BGA TECHNICAL COMMITTEE

TECHNICAL NEWSHEET 9/10/96

Airworthiness "AGGRO" - Please add to the 1996 Pink pages.

JANUS TAIL PLANE FITTING.

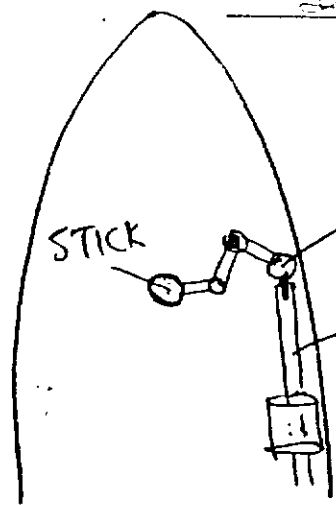
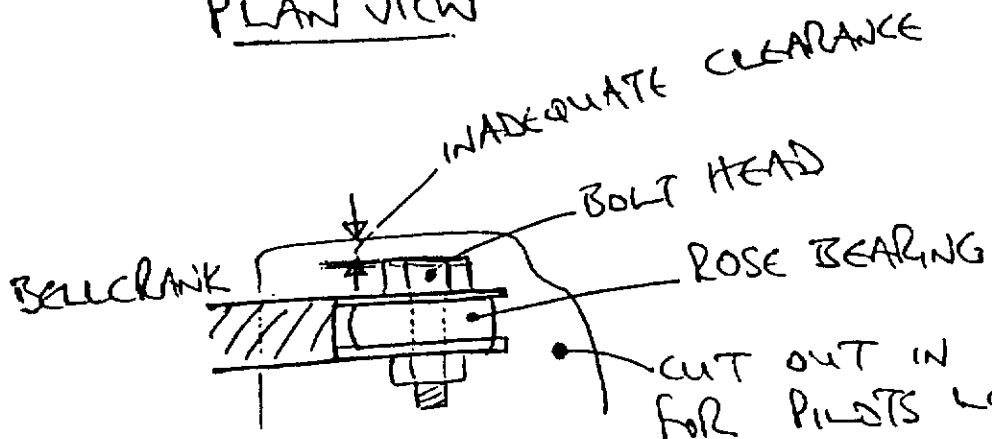
- 1.4. **Janus Tailplane** attachment fittings on the fin found cracked. (See photo). Reported by RAFGSA.
- 1.5. **KA21 - Safety Clips in Speed-Brake** Connectors attached by too long lanyards, were extracted from the L'hotelliers when the brakes were operated! (Southdown G.C.).

CUT INSPECTION HOLES IN LOWER SURFACE OF BOTH WINGS AS SHOWN

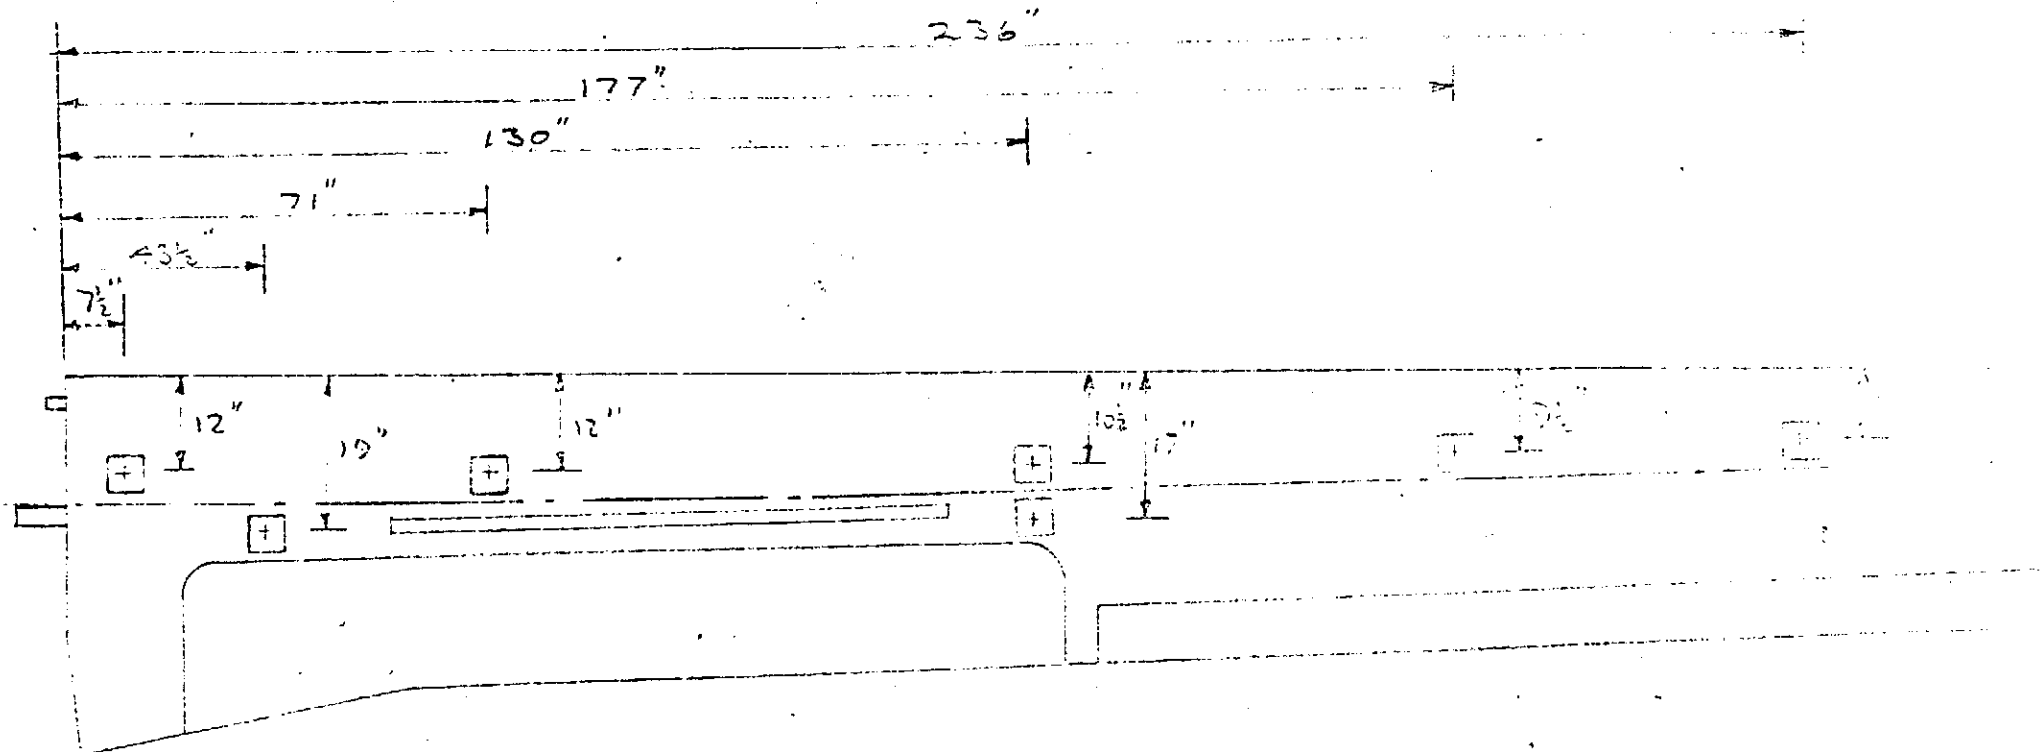
1. Mark the hole centres as shown on the diagram, drill $\frac{1}{2}$ " dia. hole in the ply and gradually open up the holes to 3" - 4" square.
2. Thoroughly inspect the metal portion of the spar paying particular attention to bolted joints and rib attachment points.
3. If any significant corrosion exists, that is more than 0.007" in depth the aircraft will require repair action.
4. The holes in the wing should be repaired in accordance with standard practice and the results of the inspection sent to Slingsby Sailplanes.
5. After the results of the inspection have been analysed by Slingsby Sailplanes further action may be required on an annual basis.

Bras d'aérofreins

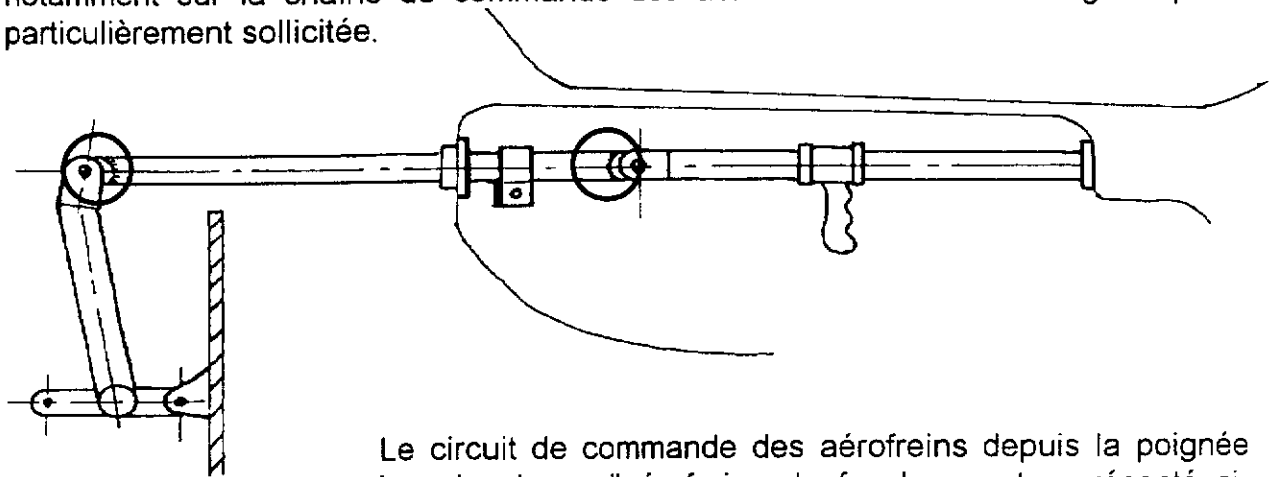
Le circuit de commande des aérofreins depuis la poignée jusqu'au bras d'aérofreins du fuselage est représenté ci-contre. Un contrôle visuel minutieux de toutes les parties soudées et en particulier des parties encadrées doit être effectué, si besoin, à l'aide d'un miroir et d'une lampe et après nettoyage, afin d'y déceler un éventuel début de crique.

NOTA: Etant donné la difficulté éventuelle d'analyse des soudures du bras d'aérofreins (repéré sur le croquis ci-dessus) par des opérateurs n'ayant pas l'habitude de tels contrôles, nous conseillons vivement, par mesure préventive, de remplacer ce bras par la pièce \$Y57D pour les planeurs équipés de branchement manuel des commandes d'ailerons et d'aéro-freins et la pièce \$Y818E pour les planeurs équipés de branchement automatique de ces commandes. Ces pièces ont été renforcées par sécurité pour limiter le risque d'apparition de criques en cas de fortes surcharges en utilisation.

Bras d'aérofreins

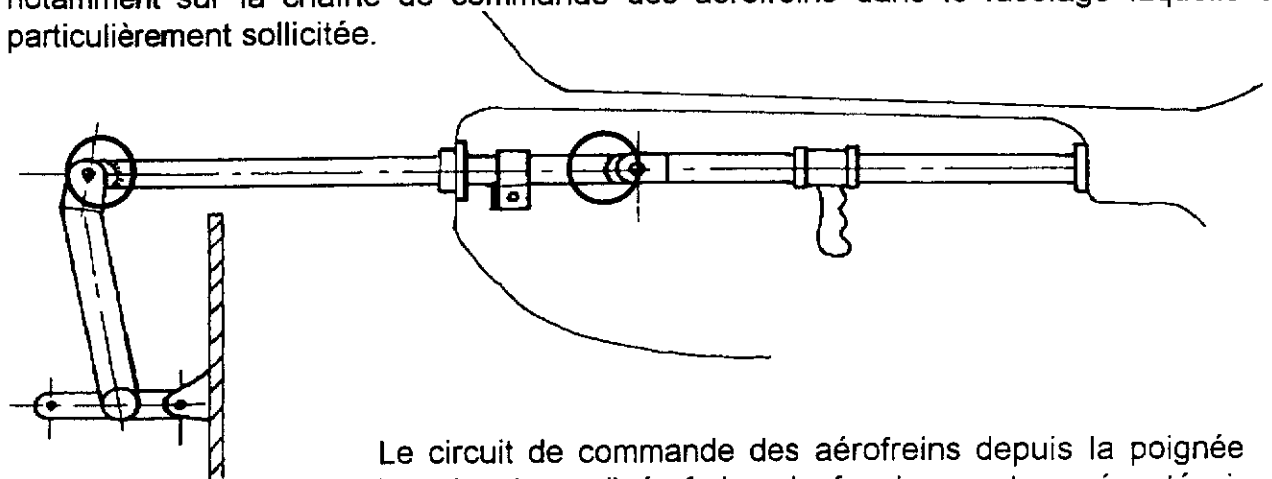
Le circuit de commande des aérofreins depuis la poignée jusqu'au bras d'aérofreins du fuselage est représenté ci-contre. Un contrôle visuel minutieux de toutes les parties soudées et en particulier des parties encadrées doit être effectué, si besoin, à l'aide d'un miroir et d'une lampe et après nettoyage, afin d'y déceler un éventuel début de craque.

NOTA: Etant donné la difficulté éventuelle d'analyse des soudures du bras d'aérofreins (repéré sur le croquis ci-dessus) par des opérateurs n'ayant pas l'habitude de tels contrôles, nous conseillons vivement, par mesure préventive, de remplacer ce bras par la pièce \$Y57D. Cette pièce a été renforcée par sécurité pour limiter le risque d'apparition de criques en cas de fortes surcharges en utilisation.
